FPD LINK III - R

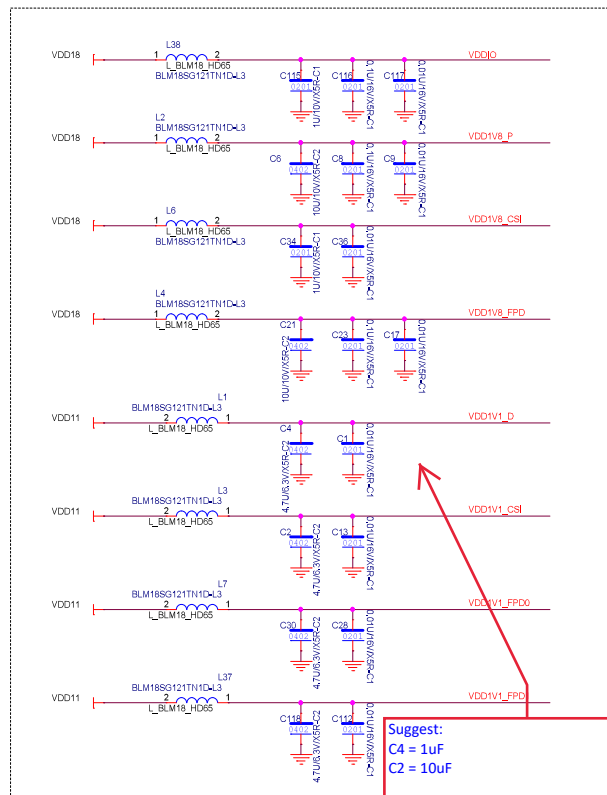
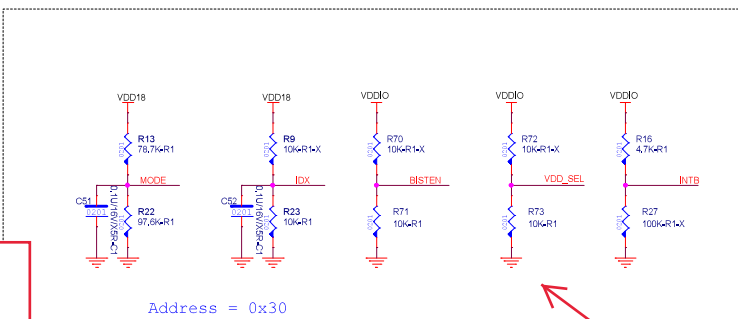
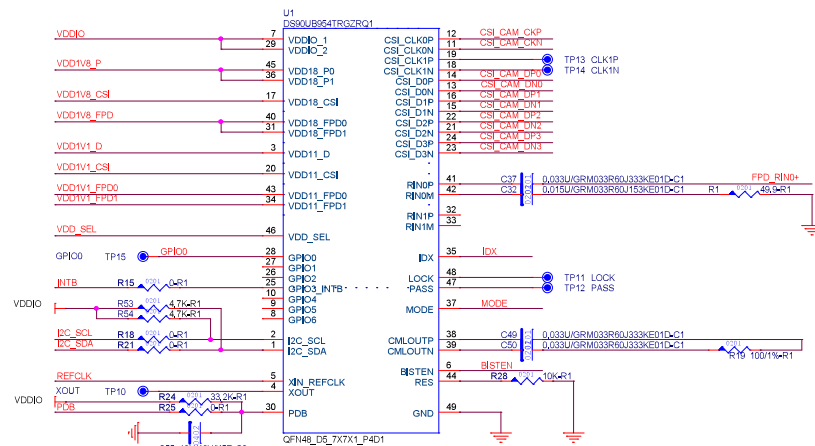
Suggest:
C4 = 1uF
C2 = 10uF

Group VDD1V1_FPD0 and VDD1V1_FPD1.
Use one 10uF cap for both nets and then
1x 0.01uF cap for each pin

Address = 0x30

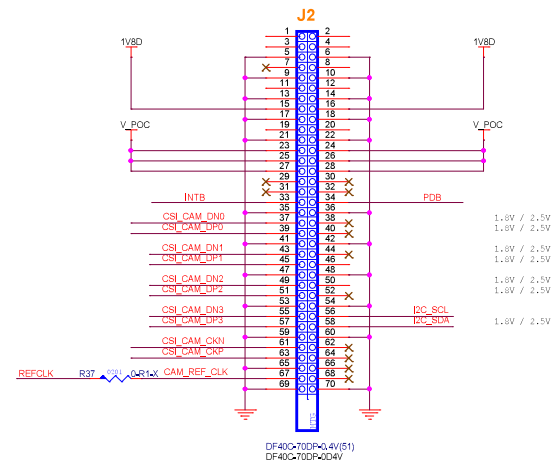
PoC network does not match datasheet recommendation. Suggest to use PoC network exact components from the 954 datasheet

Schematic looks to be configured for external VDD11 mode so VDD_SEL should be high
